ON-SITE SEWAGE DISPOSAL SYSTEM HOWARD COUNTY HEALTH DEPARTMENT BUREAU OF ENVIRONMENTAL HEALTH

04-363213

ADDRESS: 1402 Morgan Station Road PROPERTY OWNER: Ray & Linda Everett

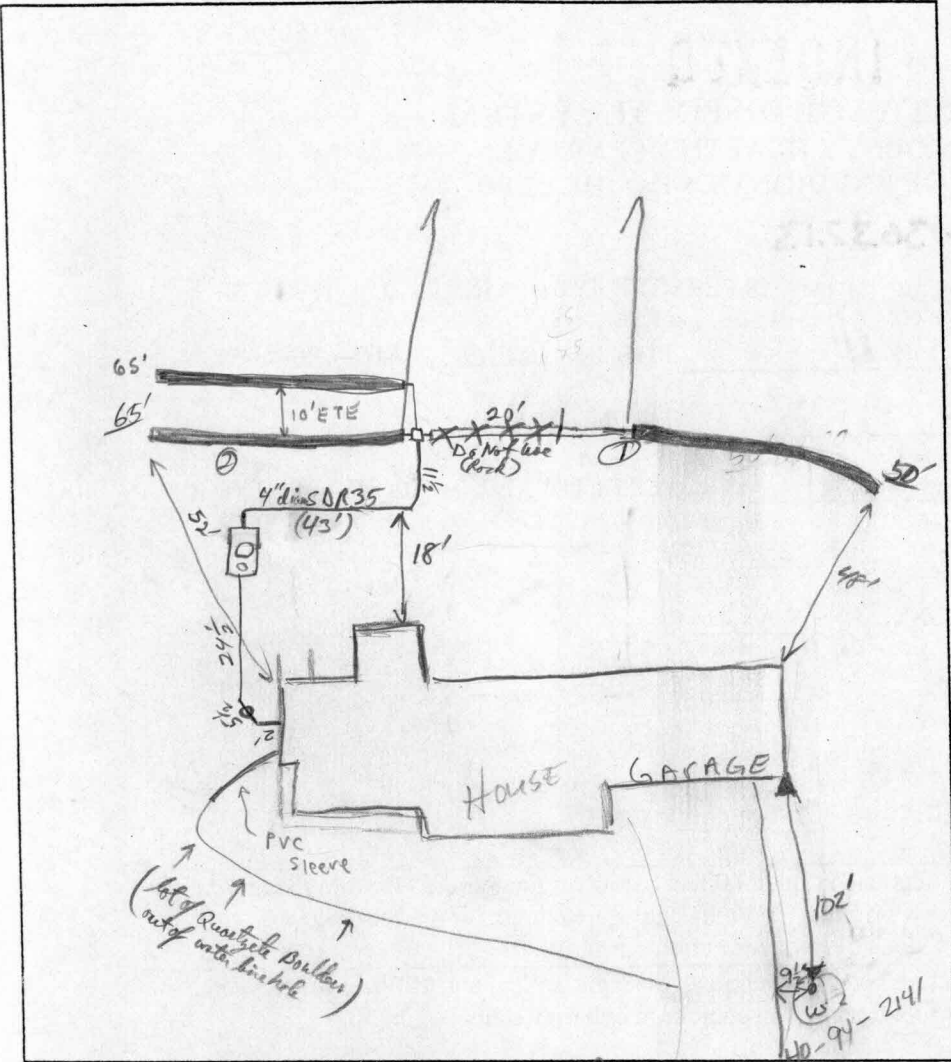
Moroccan Station Road
 PRE-CONSTRUCTION INSPECTION: 8/27/01 Well needs to be 15' from driveway

Begin trench layout per plan. Septic pipe begins under footing (KG/BIB)

INSPECTION COMMENTS: Start, part of supply line in, First Trench - Front 25ft has very bad bottom, Do Not use Front 25ft (Backfill with sand + bridge to solid pipe) OK to run rest two trenches in opposite direction. 8/28/01 Trench #2 gravel filled + piped (except end which was open - OK - No Rock in Trench), Trench #1 Front 20' had filled with dirt + bridged to 20' of solid pipe - then 50ft of usable Trench OK. OK to cover both Trenches when paperwork. House Connection OK. 8/29/01 8/30/01 - OK TO COVER ALL WORK - (SRU)

8/28/01 WPT, pitless adapter OK, needs apt condnt pipe, grant OK, well line not connected to house yet. 8/29/01
